PUBLIC HEARING/WORKING SESSION MEMORANDUM

PETITION #314-20

23 Johnson Pl.

Petition #314-20, for SPECIAL PERMIT/SITE PLAN APPROVAL to allow four three single-family attached dwelling units in two structures, to allow a retaining wall in excess of 4' and to allow a driveway within ten feet of the side lot line at 23 Johnson Place, Ward 4, Auburndale, on land known as Section 41 Block 7 Lot 14, containing approximately 16,767 sq. ft. of land in a district zoned MULTI RESIDENCE 1. Ref: Sec. 7.3.3, 7.4, 3.2.4, 5.4.2.B, 6.2.3.B.2 of Chapter 30 of the City of Newton Rev Zoning Ord, 2017.

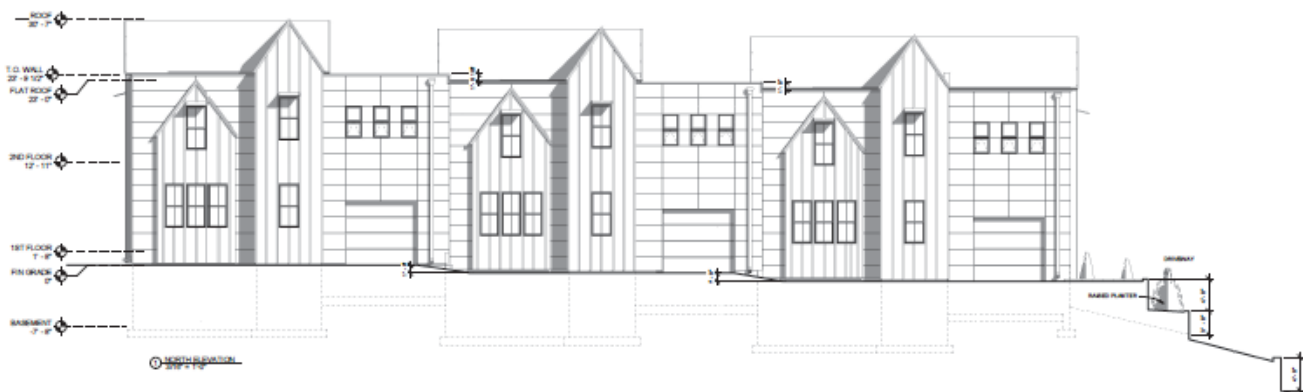
The Planning Department notes that while the number of units has been reduced, the size relative size of construction on the site has not. Also, rather than dividing the bulk into two structures as previously proposed, the single building presents as one long building stretching across much of the depth of the lot, especially along its right side, as seen in the below drawing (the rear of the site is to the right).
